DESIGN RF	DRAWN BY	LTD	
CHECKED	APPROVED	DRAWING NO. DSI 9189 SHE	REV. A
DATE		TITLE	SCALE
00.05.23		AFT AND SIDE DOOR LATCH MOD.	NTS
A	00.05.23	NEW ISSUE

DART SERVICE INSTRUCTION

TO AMEND INSTALLATION DRAWINGS: D350-588 REV. A OR EARLIER D350-589 REV. A OR EARLIER

THE PURPOSE OF THE DSI 9189-011 KIT IS TO PROVIDE THE HARDWARE TO REPLACE THE D2443 LATCHES (REF. HARTWELL PART NUMBERS H605S190A496 OR H2818-3S125A OR H605K3240) WITH D2586 LATCHES.

FIGURE 1: TYPICAL DOOR CUTOUT

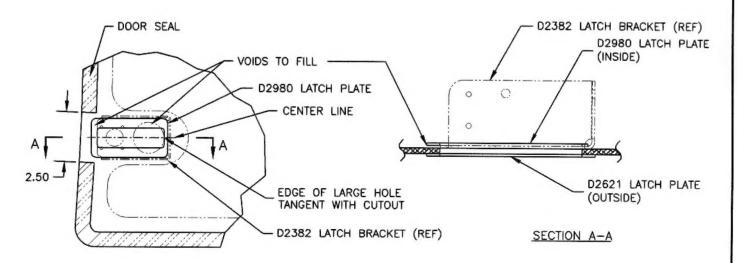
- REMOVE EXISTING D2443 LATCH AND D2383 LATCH BRACKET COVER FROM THE DOOR. DO NOT REMOVE D2382 LATCH BRACKET.
- 2. REMOVE 2.5" (MAX) OF SEAL FROM EDGE OF THE DOOR PER FIGURE 1.

- 3. DRAW A LINE CONNECTING THE CENTRES OF THE TWO LARGE HOLES FOR THE EXISTING LATCHES.
- 4. LINE UP THE INSIDE EDGE OF THE D2980 LATCH PLATE WITH THE EDGE OF LARGER LATCH HOLE AS SHOWN IN FIGURE 1. MAKE SURE THE D2980 LATCH PLATE IS CENTERED ON THE LINE CREATED AT STEP 3.

- USING THE D2980 LATCH PLATE AS A TEMPLATE, MARK THE CUTOUT PROFILE FOR THE LATCH.
- 6. CUT A HOLE IN THE DOOR PER THE PROFILE CREATED AT STEP 5. TRIM TO FIT D2586 LATCH.

FIGURE 2: TYPICAL LATCH INSTALLATION

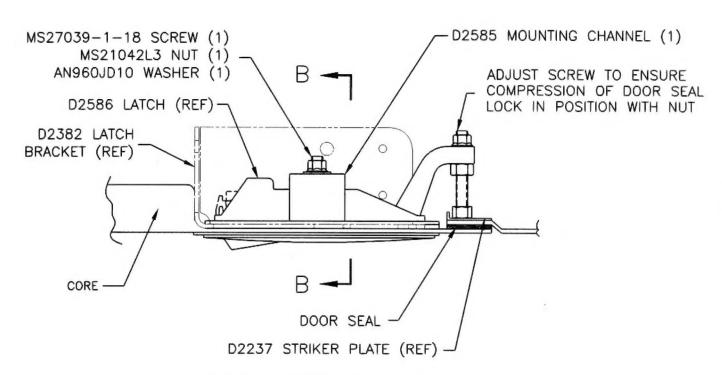
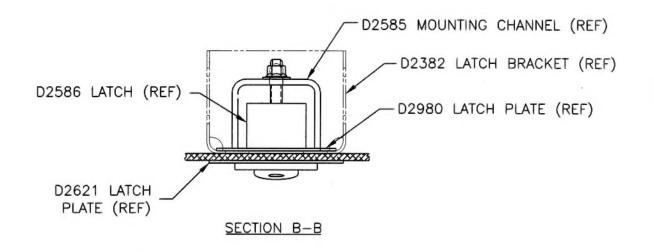
- CLEAN THE INSIDE OF D2382 AND OUTSIDE OF THE DOOR IN THE VICINITY OF THE D2621 AND D2980 LATCH PLATES WITH ACETONE.
- 8. INSTALL D2621 LATCH PLATE OUTSIDE AND D2980 LATCH PLATE INSIDE OF THE DOOR AS SHOWN IN SECTION A-A USING 5 MIN. EPOXY OR PRC. ENSURE THAT THE LATCH PLATES LINE UP WITH THE RECTANGULAR CUTOUT FOR THE D2586 LATCHES. CLAMP LATCH PLATES IN PLACE. FILL THE VOID BETWEEN THE D2621 AND D2980 LATCH PLATES AS SHOWN IN FIGURE 1 WITH 5 MIN. EPOXY OR PRC. WIPE AWAY EXCESS EPOXY OR PRC FROM ALL AROUND THE LATCH PLATE INSTALLATION. ALLOW AT LEAST 15 MIN. BEFORE REMOVING CLAMPS AND PROCEEDING TO THE NEXT STEP.

- 9. INSTALL REPLACEMENT D2463-0025 NEOPRENE SEAL OVER THE D2980 LATCH PLATE.
- 10. INSTALL D2586 LATCH AND D2585 MOUNTING CHANNEL PER FIGURE 2.
